# CITY OF ALBUQUERQUE

**RE: Eagle Ranch MVD-Retail (Phase 1: MVD Building)  
Eagle Ranch Rd (Tract C, Cottonwood Pointe)  
Request for Certificate of Occupancy – Permanent  
Hydrology Final Inspection - Disapproved  
Engineer's Stamp Date 8/22/17 (B13D002C)  
Certification Dated: 3/1/18**

TYPICAL POND SECTION G  
NTS C-3.0

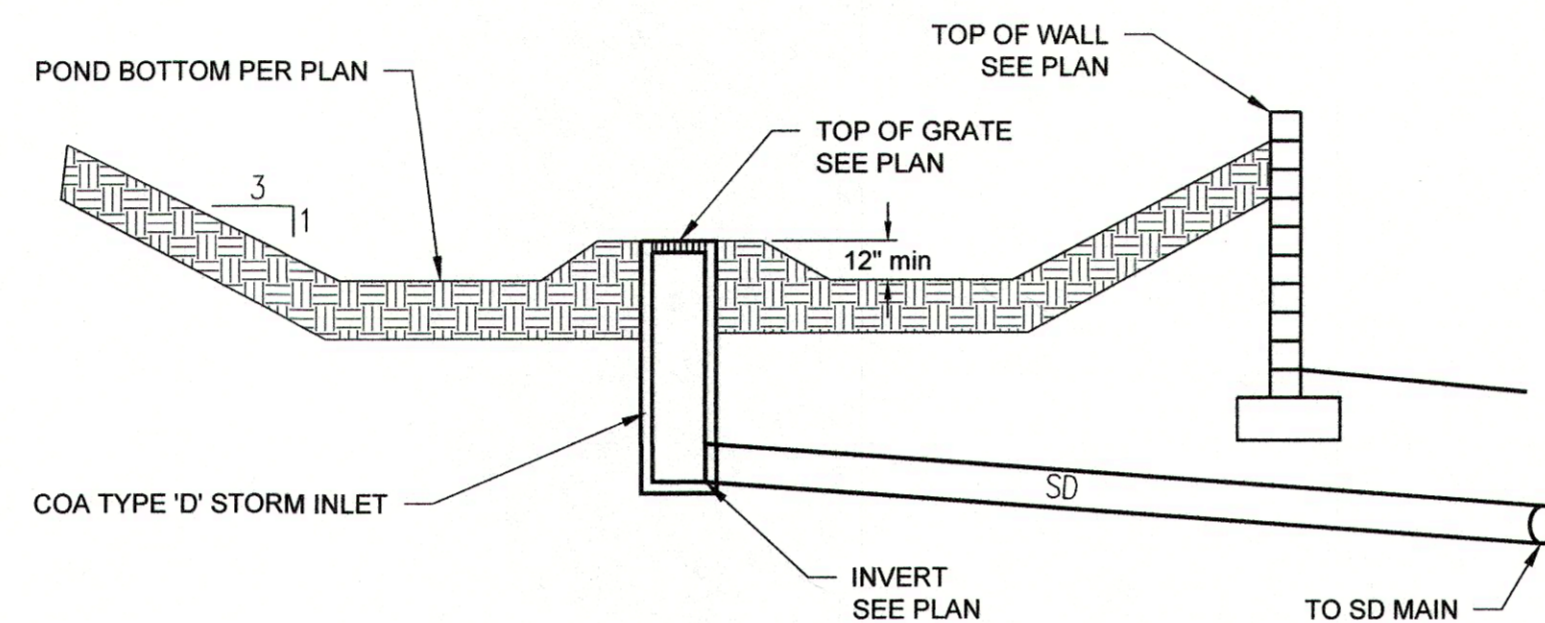
1. First Flush Pond "B" needs to be deepened to 12" below top of grate in order to provide first flush ponding, per detail G, C-3.0:

OVERFLOW SPILLWAY H  
NTS C-3.0

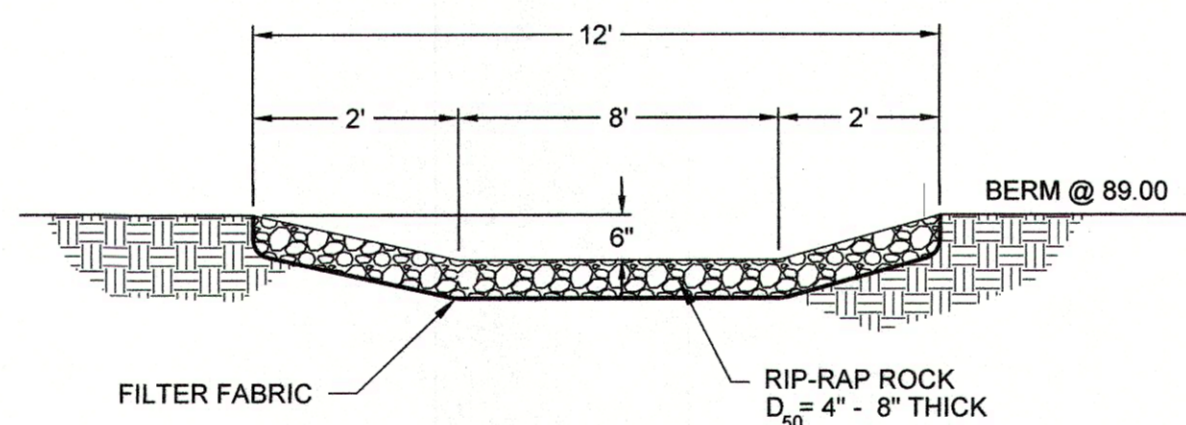
2. The rock for the emergency spillway needs to be replaced with d50=4" rock, per detail H, C-3.0:
